# Product Change Notification

## 110874 - 00

**Change Notification #:** 110874 - 00  
**Change Title:** Intel(R) Server Chassis P4304XXSFCN,  
Intel(R) Server Chassis P4304XXSHCN,  
Intel(R) Server System P4304BTL SFCN,  
Intel(R) Server System P4304BTL SHCN,  
PCN 110874-00, Product Design, Product  
Design, Chassis design improvement  
**Date of Publication:** July 21, 2011

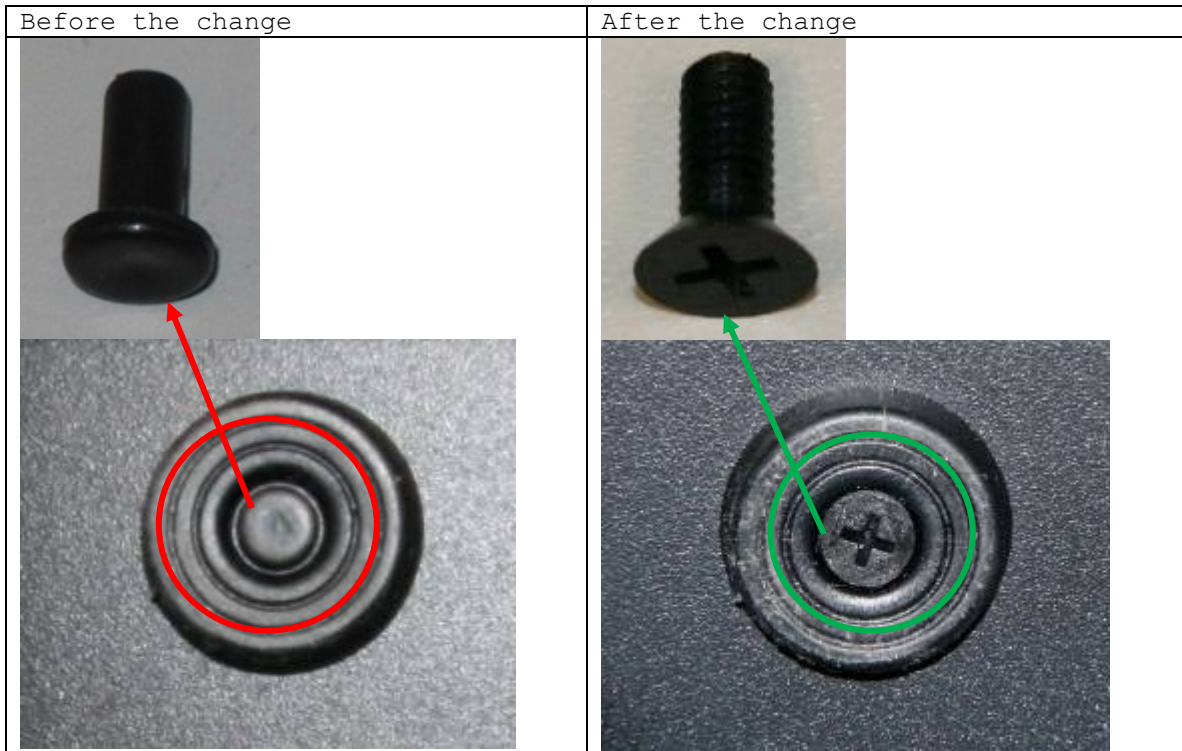
1. Intel will implement the following changes on the Intel(R) Server Chassis P4304XXSFCN and P4304XXSHCN, Intel(R) Server System P4304BTL SFCN and P4304BTL SHCN:
  - 1.1 Add a blue plastic cap to the Optical Disk Drive (ODD) rail user access point. The following are pictures of prior and post change:

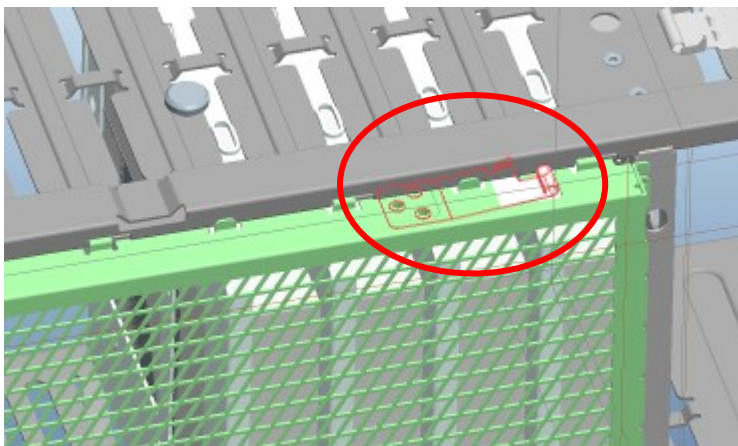
- 1.2 Replace the chassis feet plastic pin with a plastic M4 screw, so the chassis feet can be removed by unfastening the screw with a screwdriver from outside of the chassis. The following are pictures of prior and post change product :
